Submissions Report

Major Project 05-0038

Proposed Subdivision of Lot 542 DP113791, Lot 156
DP753202 and Lot 53 DP836998

Date: 13 April 2022

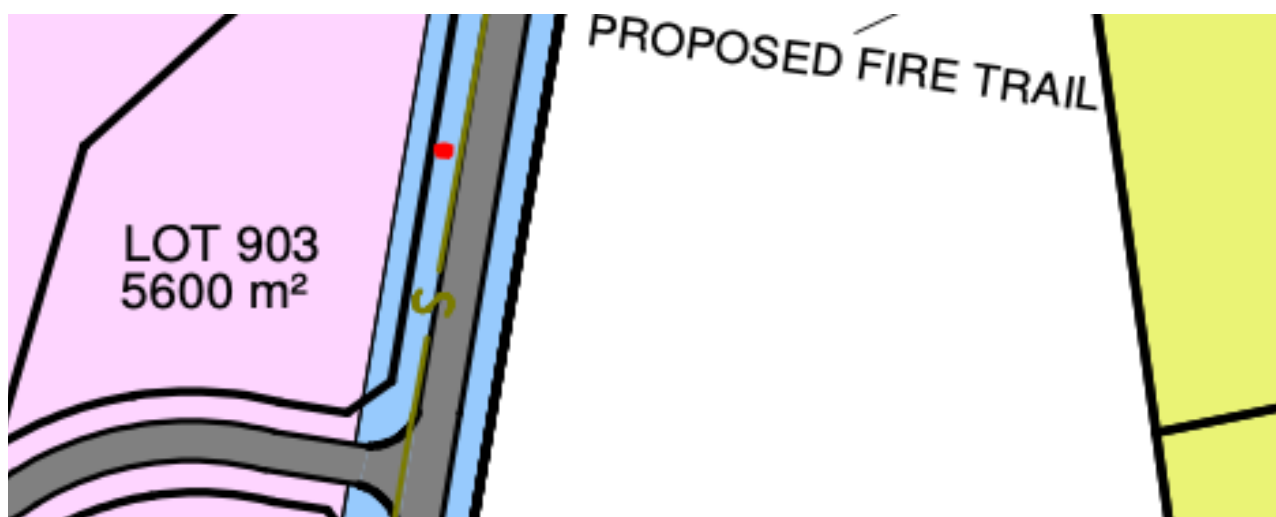
- The amended plans provide additional lots over 916 / 917 and 924. In our opinion, there is inadequate justification provided for these lots. The proposed Lot 917 appears to be divided into two separate areas. This appears impractical. The northern part of proposed Lot 917 should be deleted and incorporated into the dedicated public foreshore reserve.*

- *Proposed Lot 924 is not considered a suitable lot given its numerous constraints.*

Requirements for Asset Protection Zones and following requests from Midcoast Council, there has been a reduction in the number of lots in Stage 2 of the proposed subdivision as follows:

- Deletion of former Lots 923 and 924;
- Consolidation of former Lots 916 and 917 into one larger lot; and
- Incorporation of part of the former Lot 917 into the future Public Reserve to be dedicated to Council.

These changes to the Stage 2 lot layout are shown in the subdivision plans contained in **Appendix C**.
